Service Bulletin

SUBJECT: Service Update for Inventory and Customer Vehicles - Front Lower Control Arm Rear Link Ball Joint Re-torque – Both Sides
Expires with Base Warranty

MODELS: 2014-2015 Chevrolet Caprice, Caprice PPV, SS

1949920

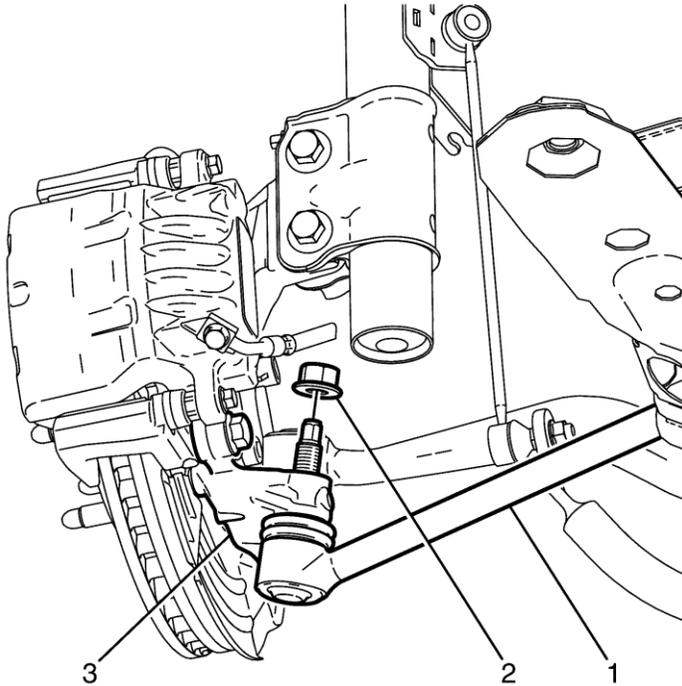
This bulletin provides a service procedure to re-torque the front lower control arm rear link ball joint nuts on **certain** 2014-2015 model year Chevrolet Caprice and SS vehicles. These vehicles may have under torqued front lower control rear link ball joint nuts. This condition may result in a clunk or rattle type noise in the front suspension.

Use the following steps to re-torque the front lower control arm rear link ball joint nuts. The nut will need to be torqued to a maximum value to seat the joint, then loosened and torqued to the correct specification. This procedure must be carried out on both the left and right front lower control rear link ball joints.

Note: It is not necessary remove the wheel.

Note: It is not necessary to replace the nut with a new part.

Note: Ensure the procedure is repeated on both sides of the vehicle.

1. Raise and support the vehicle. Refer to *Lifting and Jacking the Vehicle* in SI.
2. Torque the existing front lower control arm rear link (1) ball joint nut (2) to **150 Nm (111 lb-ft)** to fully seat the joint in the steering knuckle (3).
3. Loosen the ball joint nut (2) 180 degrees.
4. Re-torque the ball joint nut (2) to **55 Nm (41 lb-ft)**.
5. Tighten nut another 30 degrees.
